REMARKS

-- ANNOTATED, MARKED-UP DRAWINGS --

Inventor: Soo Young Choi et al.  
Serial No.: 10/829,016  
Title: Controlling the Properties and Uniformity . . .  
Docket No.: AM-9230  
Phone: S. L. Church

Fig. 3C

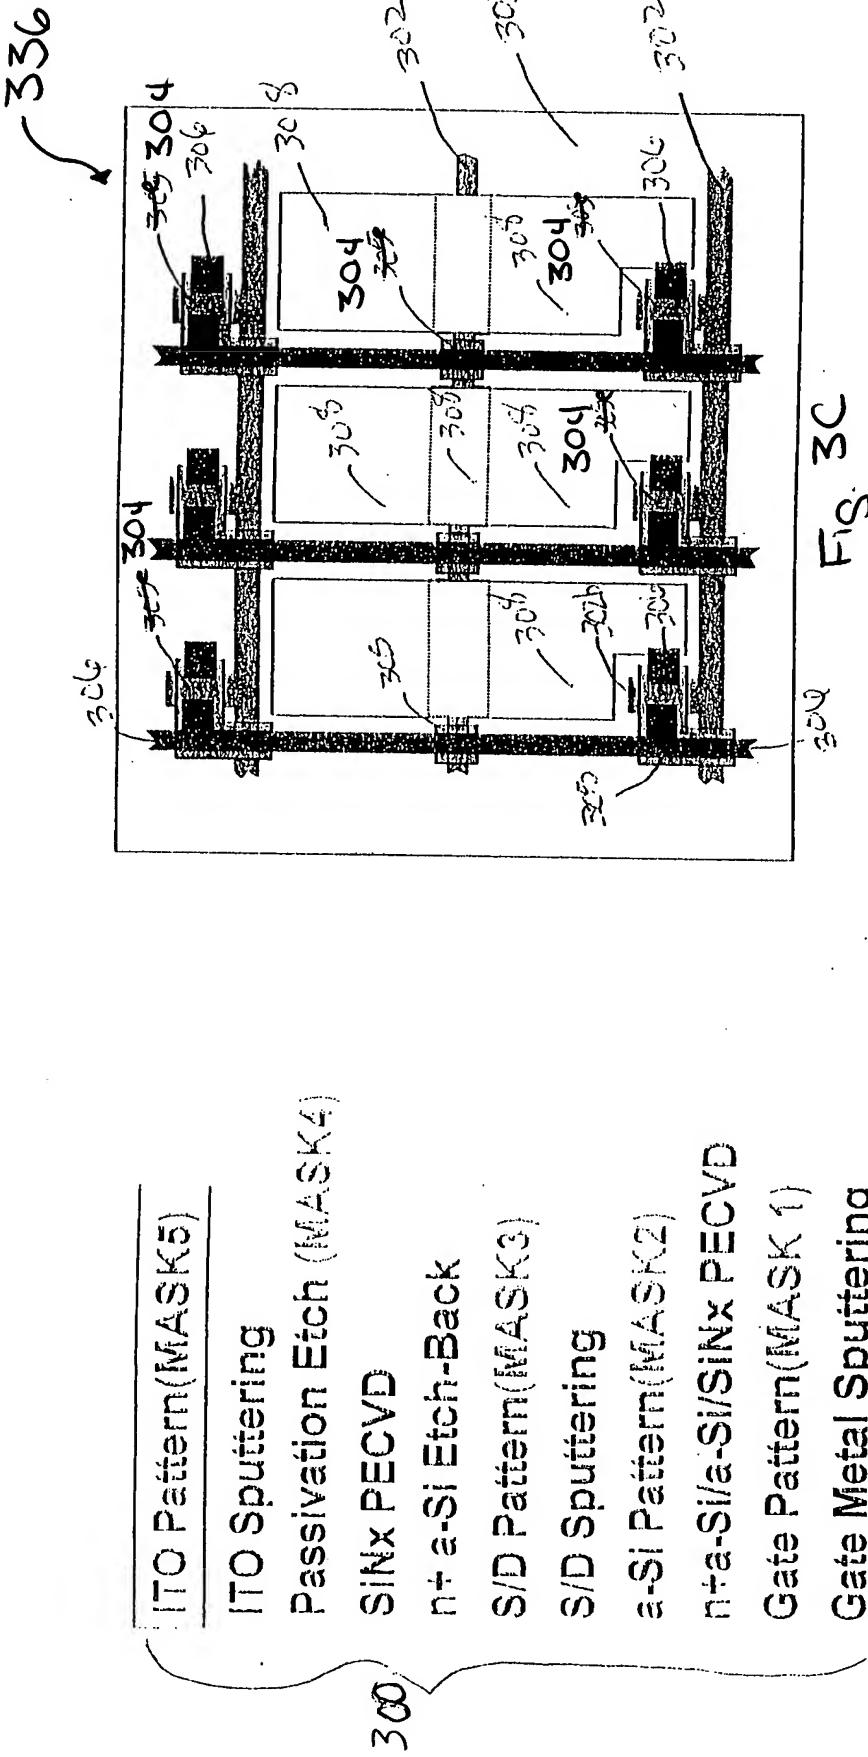
Further, applicants have amended Figure 3C to add reference numeral 336, which indicates the schematic top-view of a substrate including several TFT structures of the kind which is illustrated in Figure 3B. The schematic top-view 336 was described at page 17, lines 22 - 23, of applicants' originally filed specification, but reference numeral 336 was inadvertently omitted from the original Figure 3.

Applicants have also amended Figure 3C to correct a labeling error which was present in the original figure. On the original Figure 3C, the elements identified using reference numeral 305 should have been labeled with reference numeral 304. Applicants have therefore amended Figure 3C to change each occurrence of reference numeral 305 to reference numeral 304. This amendment is being made for the purpose of correcting a technical error in the numbering of elements on Figure 3C which is not related to the novel and inventive portion of applicants' claimed invention. According to Paragraph [0063], at page 18, lines 19 - 22, of applicants' originally filed specification: "In the seventh step in the process, "n<sup>+</sup> a-Si Etch-Back", the portion of the "n<sup>+</sup> a-Si layer 305 which was exposed by the patterned dry etch in the sixth step is etched back using techniques known in the art. "n<sup>+</sup> a-Si layer 305 is etched completely through, and is "overetched" into underlying layer 304 of a-Si." Since n<sup>+</sup> a-Si layer 305 would have been etched completely through, n<sup>+</sup> a-Si layer 305 should not be shown in Figure 3C, and the layer that is actually shown is the underlying a-Si layer

304, which has been exposed upon etchback of the n+ a-Si layer 305. The correction to the drawing is necessary to correctly depict the structure resulting after n+ a-Si layer etchback.

Fig. 3A

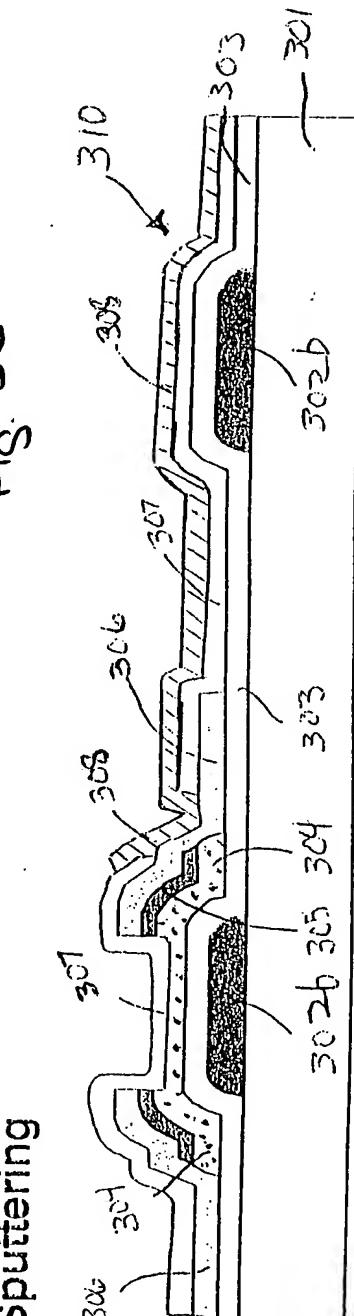
Enclosed is a set of four (4) sheets of informal drawings, which have been labeled "ANNOTATED, MARKED-UP DRAWINGS". Changes are being made only to Sheet 3 of the drawings. Proposed changes to Sheet 3 are shown in red ink. In particular, Sheet 3 shows three distinct figures. These three distinct figures were originally labeled together as Figure 3. On the marked-up, amended Sheet 3 submitted herewith, applicants have re-labeled the three distinct figures as Figures 3A, 3B, and 3C.

Applicants' specification has been amended accordingly, as set forth above, to include references to Figures 3A, 3B, and 3C.
